TRINITY PARKWAY ADVISORY COMMITTEE REPORT

by Angela Hunt and Rep. Rafael Anchia

March 21, 2016

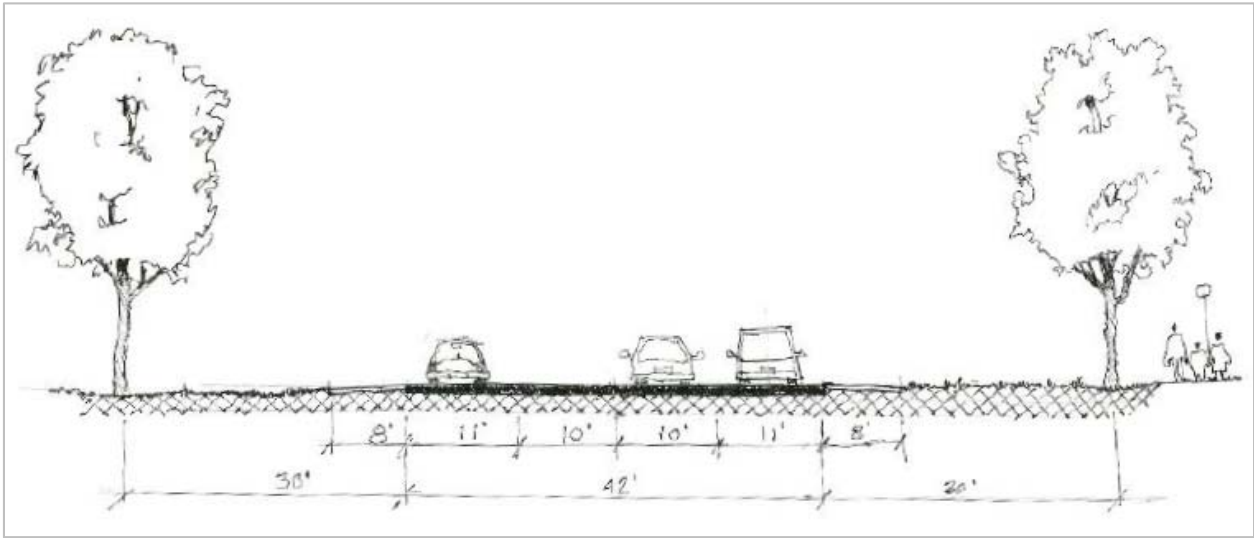
The meanders proposed in the Charrette Vision are the most prominent physical characteristic constraining the speed of the road. Tighter curves require drivers to maintain a lower speed, which is more appropriate to a park setting. The Technical Design has straightened the meanders, thus allowing for higher travel speeds.

Although the Technical Design's meanders ostensibly result in a design speed of 45 mph, further investigation of the geometry of the curves indicates that they would actually support much higher speeds. A design speed of 45 mph correlates with a curve radius of 1039 feet,³ yet the radii of most of the curves in the Technical Design are 2000 feet or more.⁴ To put this in perspective, a low-speed park-adjacent road like Turtle Creek Parkway has meanders with an average radius of 400 feet, resulting in a posted speed limit of 30 mph.

RECOMMENDATION: Direct the Technical Design Team to revise the meanders to reflect an anticipated 85th percentile speed of 40 mph and a posted speed of 35 mph.

Charette Report Presentation p. 50

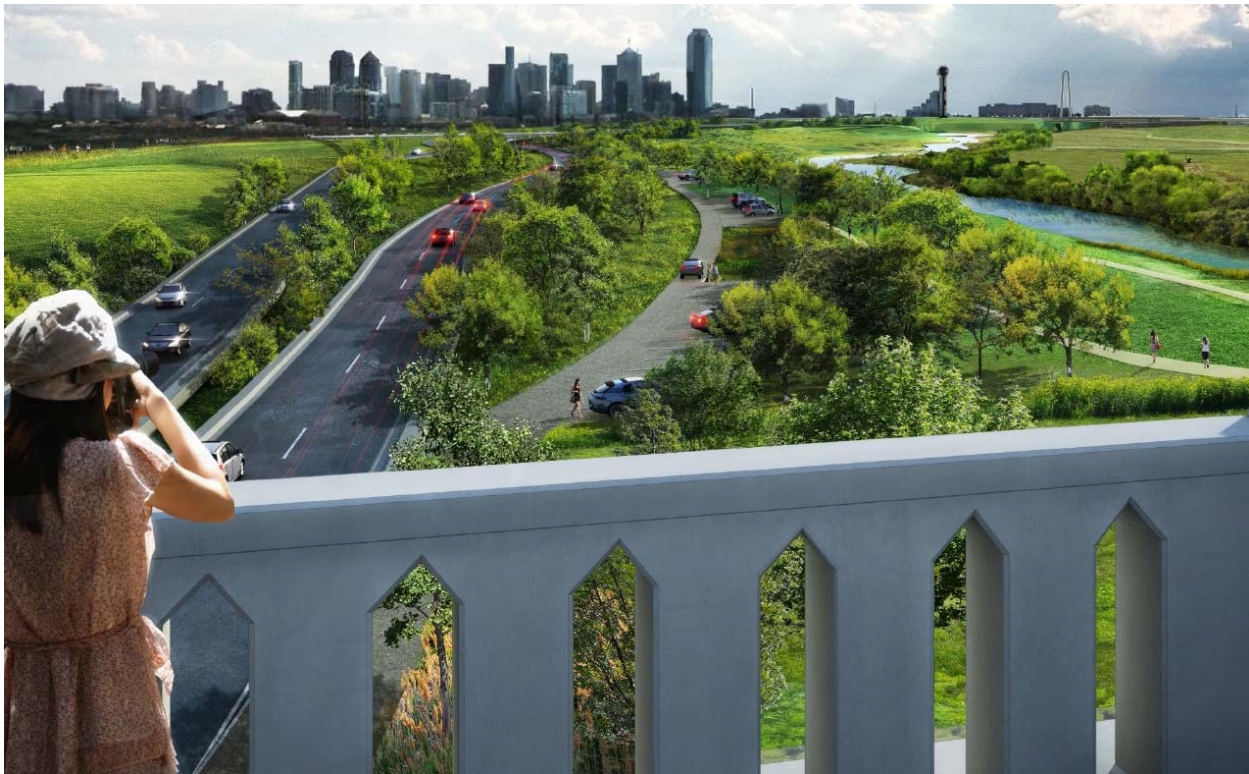
Narrow lanes constrain speed while wider travel lanes are correlated with higher vehicle speeds.⁵ The Charrette Vision showed roadway lanes with widths of 10 and 11 feet, with 42 feet of total pavement:

In the Technical Design, however, the lanes grew to 11 and 12 feet, plus 2 more feet of pavement between the road and the shoulder, resulting in 50 feet of pavement. These widths are indicative of highways and other high-speed roads appropriate for trucks, not a park access road.⁶

RECOMMENDATION: Direct the Technical Design Team to design the road as presented in the Charrette Vision, with 10 and 11 foot lanes, and without the additional 2 feet of pavement.
